SUB-COMMITTEE ON SHIP SYSTEMS AND
EQUIPMENT
11th session
Agenda item 9

SSE 11/9
21 November 2024
Original: ENGLISH
Pre-session public release:

**REVIEW AND UPDATE SOLAS REGULATION II-2/9 ON CONTAINMENT OF FIRE
TO INCORPORATE EXISTING GUIDANCE AND CLARIFY REQUIREMENTS**

Proposal on a new guidance document

Regulation 9.3.4 – Prevention of heat transmission at intersections by insulation and structural detail for drainage (Source: MSC/Circ.1120)

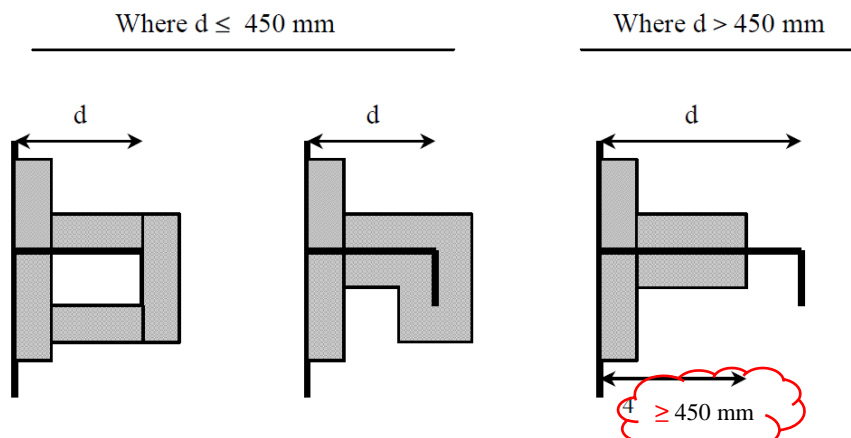
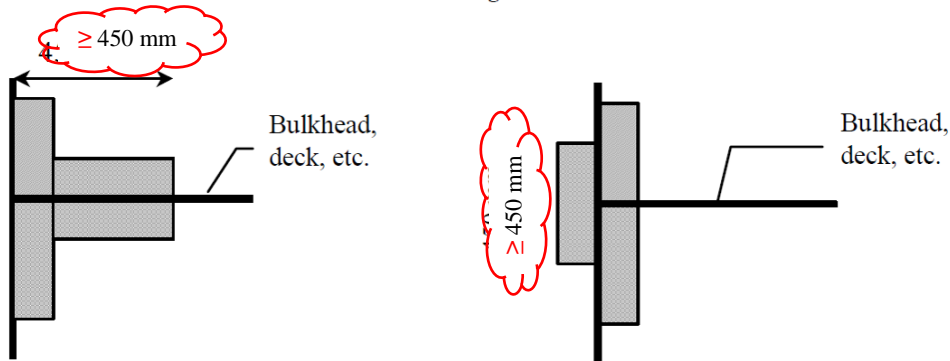
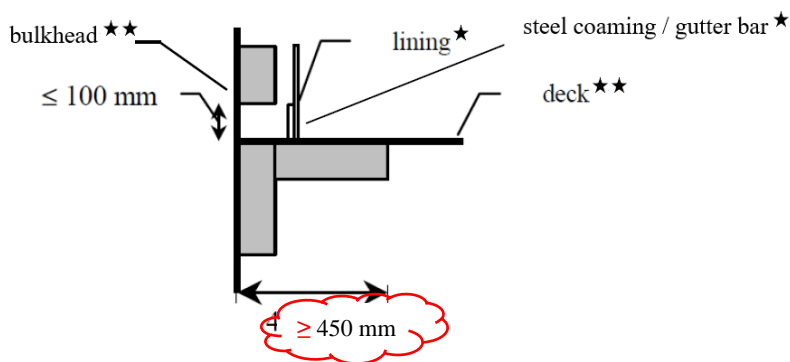
7 In the annex, clarifications of the sketches in MSC/Circ.1120, MSC.1/Circ.1510 and MSC.1/Circ.1276 are proposed to reflect the 450 mm distance requirement to prevent heat transmission. The draft clarifications are marked in the form of "clouds" for ease.

"3.4 In approving structural fire protection details, the Administration shall have regard to the risk of heat transmission at intersections and terminal points of required thermal barriers. The insulation of a deck or bulkhead shall be carried past the penetration, intersection or terminal point for a distance of at least 450 mm in the case of steel and aluminium structures. If a space is divided with a deck or a bulkhead of "A" class standard having insulation of different values, the insulation with the higher value shall continue on the deck or bulkhead with the insulation of the lesser value for a distance of at least 450 mm."
